Subject: BOSC Special Report on Hydraulic and Scour Related Topics, West Sacramento Levee Improvement Program (WSLIP), Southport

This BOSC report presents the comments and recommendations by the WSLIP's Board of Senior Consultants (BOSC) regarding Hydraulic and Scour related activities by the WSLIP consultants since the April 10, 2012 BOSC meeting report.

Bees Lake Levee Breaching Scenarios

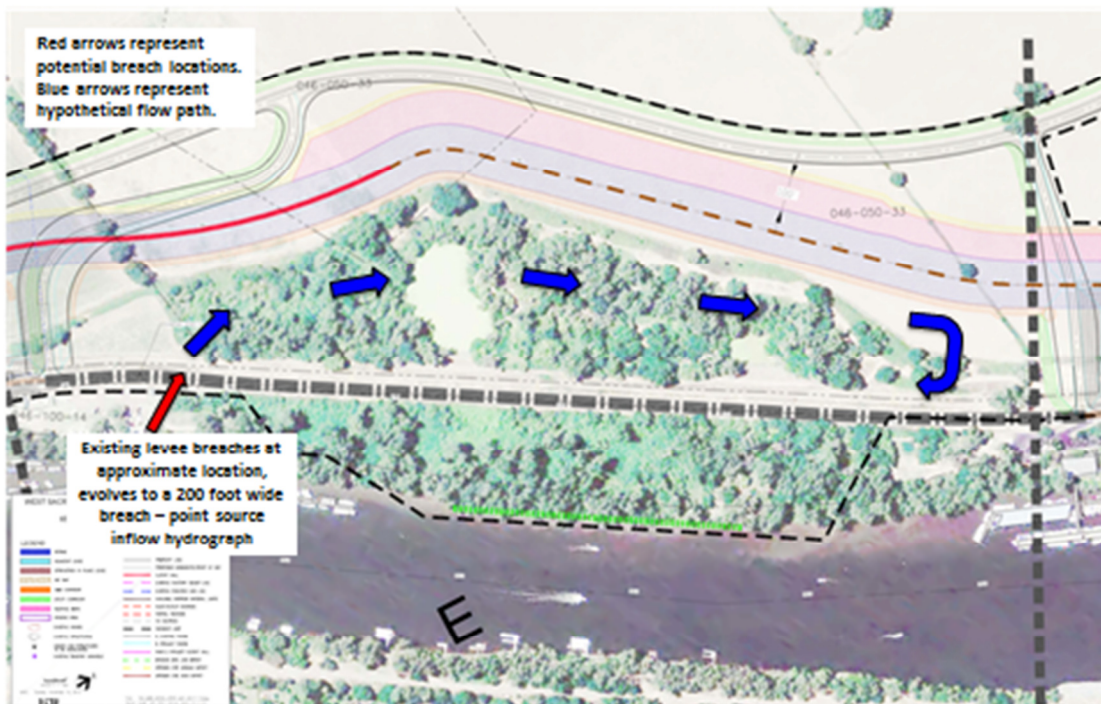
Three breach scenarios were proposed by cbec: 1) breach at downstream end of the Bees Lake reach, 2) at the access embankment of the Yacht club, and 3) simultaneous breach at the 2 locations in scenarios 1 and 2. Note that the Bees Lake area is "hydraulically connected" to the Sacramento River, mostly through underseepage, and there is almost instantaneous water level response between the two.

The BOSC endorses the 3 scenarios and the overall methodology but has a few comments. It is anticipated that the breach be performed using HEC-RAS. Since the existing levee is earthen and there would be a "pool" condition within the Bees Lake for the flood events area due to the hydraulic connection, the breach progression should be rather slow (i.e., no sudden failure) and large surges are not expected. The breach modeling should reflect this. Geotechnical information on the existing levee should be used to estimate the breach progression as well as the shape of the progression. Although hand calculations can be made to determine the hydraulic impact of surges, the BOSC does not see a need to model this phenomenon.

Appendix IV - RMA2 Velocity Contours (by MBK), Proposed Inlet

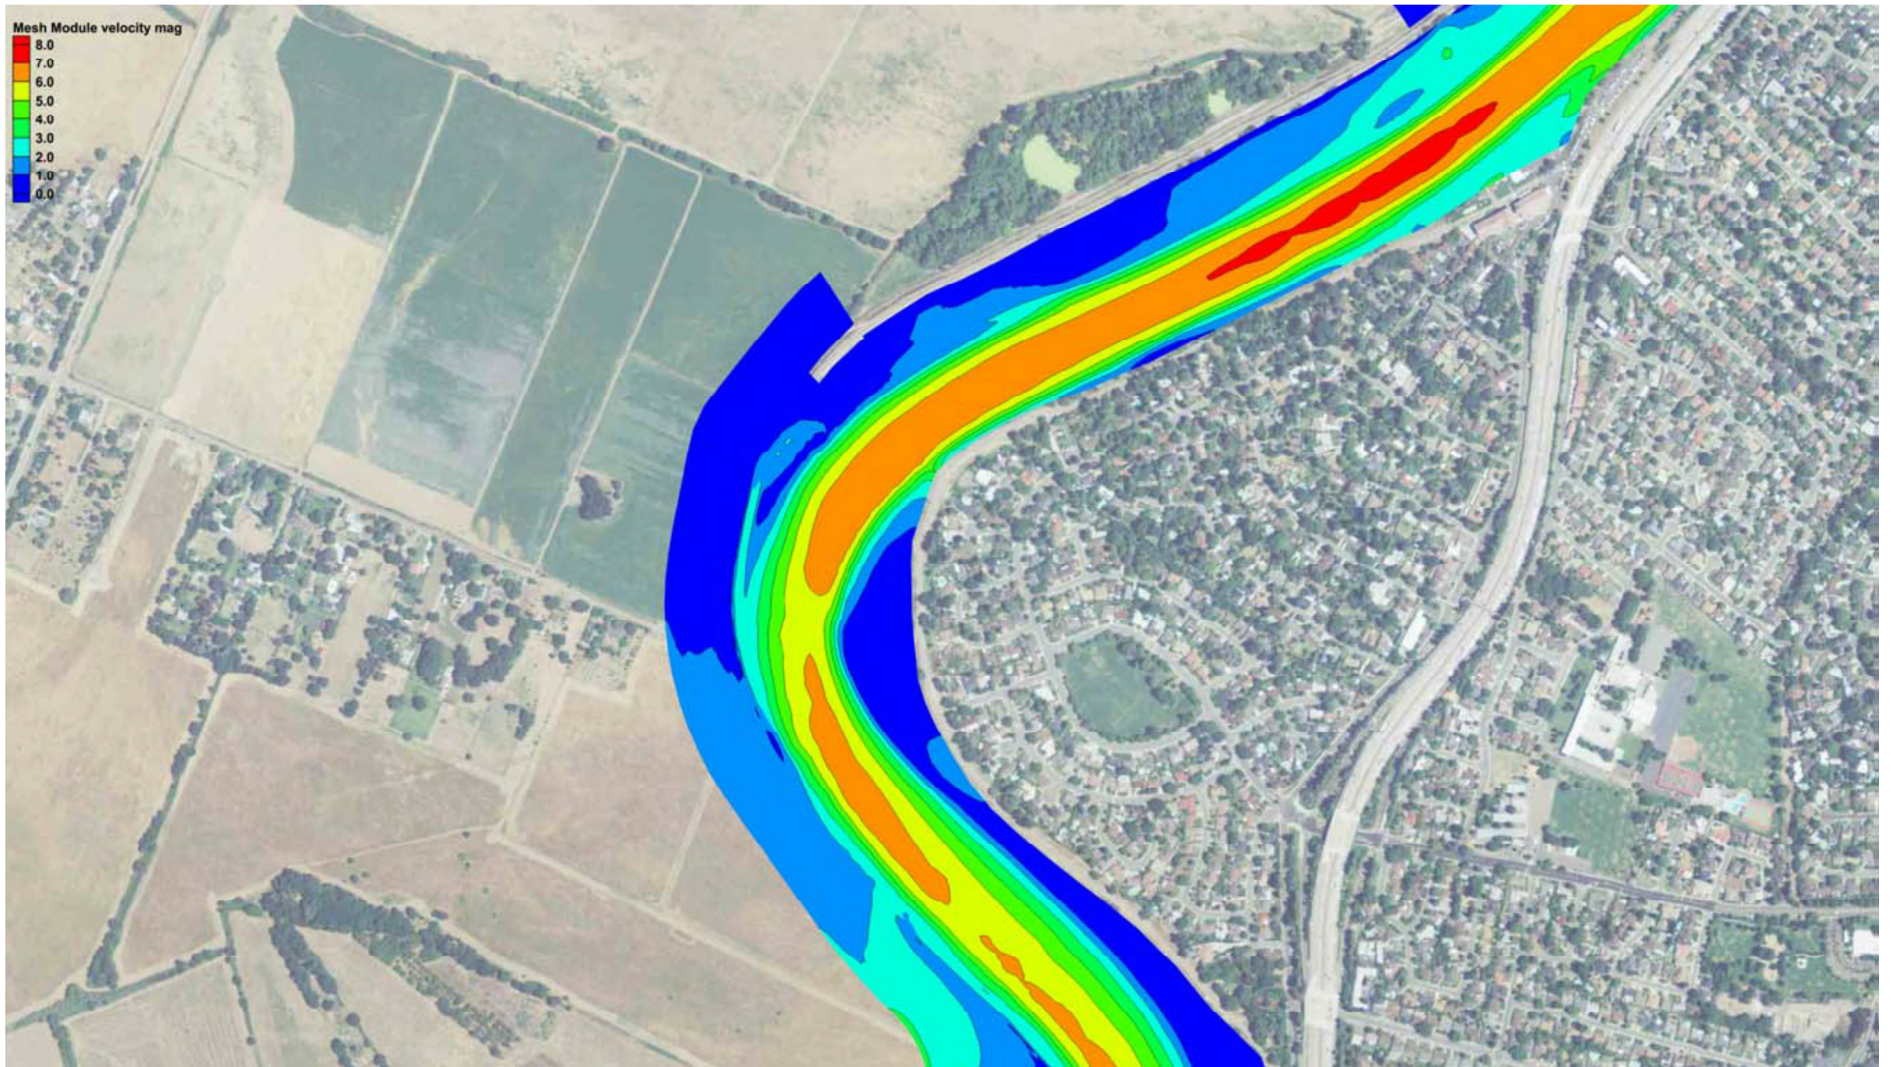
The BOSC was asked by MBK if moving the southern offset inlet (downstream of Bees Lake) upstream from its current design location would give the BOSC any concerns. The reason for the current location of the offset inlet (downstream of the 90 degree bend) was concern that if it was placed further upstream into the curve, the increased shear stress and possible impinging flow near the maximum radius of curvature could have an adverse impact on the new levee. To evaluate the impact of moving the offset inlet upstream, the BOSC examined the 200 year flood velocity contours and vectors at the area of concern for the conditions of 1) proposed inlet location, 2) existing levee not degraded, and 3) existing levee degraded. These results, shown in Appendices IV - V, were developed by RMA2 and MIKE 21c, both 2D depth averaged models. Note that the MIKE 21c results are in meters/second and the RMA2 results are in feet/second. These results do show some flow vectors perpendicular to the main channel flow as it enters the overbank area (see Appendix VI) and directed toward the outside of the bend (an indication of potential impinging flow). However, the momentum and resulting erosive force on the levee is related to impingement angle and the velocity. **Because the velocities are so small in the outside of the bend (less than about 1.5 feet/second) for all displayed cases, the BOSC has no concerns on the integrity of the new levee should the offset inlet be moved upstream. The BOSC notes that 2D vertically averaged models cannot simulate vertical vortices that occur at bends. However, this is not a concern because these vertical vortices are primarily in the main channel and become very weak as a portion of that flow goes into the overbank area. This means that the hydraulic forces in the overbanks are almost exclusively associated with the horizontal flows. Again, since these horizontal velocities are so small, the additional forces not captured in the 2D models are not of concern to the BOSC.**

Appendix V – MIKE 21c Velocity Contours (by cbec), Existing Levee Not Degraded

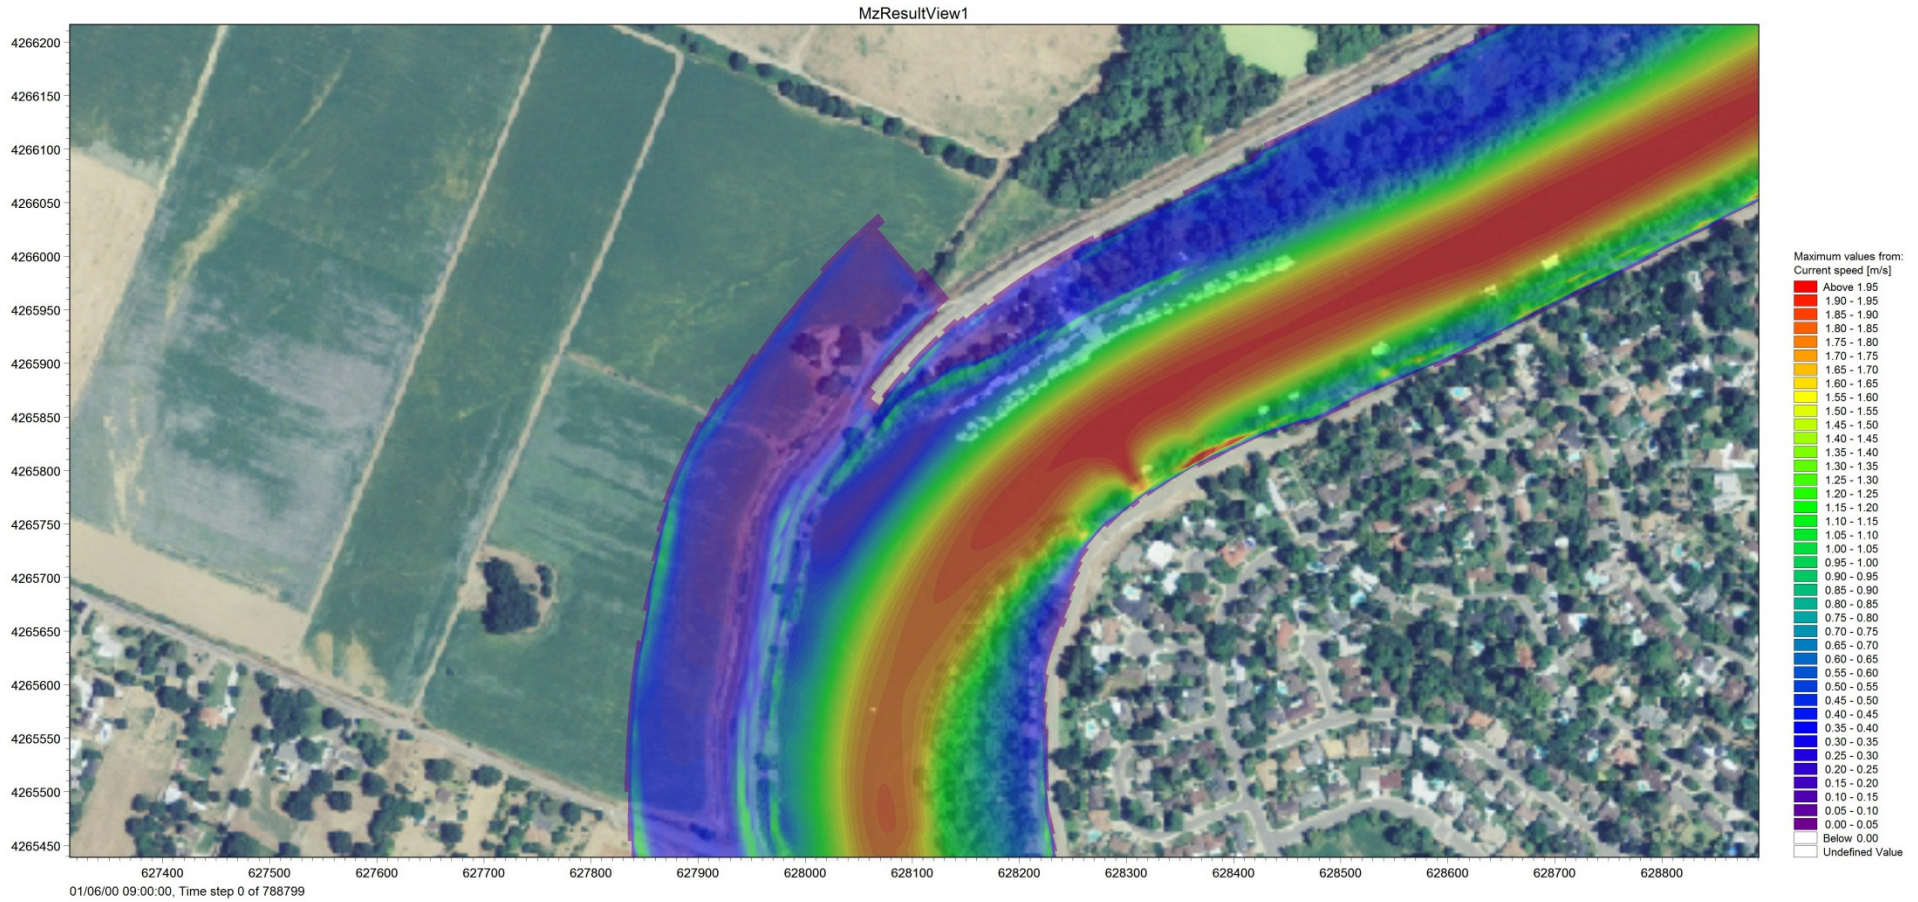
For this alternative, the flows will not overtop the existing levee for both the 100 and 200 year floods although the offset areas would be inundated with minor recirculation (eddies). The result is that there would be no overtopping waters that would go to the Yacht Club but due to the offset area essentially being a pool situation, it could collect debris and have an increased sediment deposition rate. **The BOSC believes that since the area is infrequently inundated, the long term debris issue is negligible as well as the sediment deposition issue; however, under flood conditions, there may be a short term problem but would not affect the integrity of the levee.**
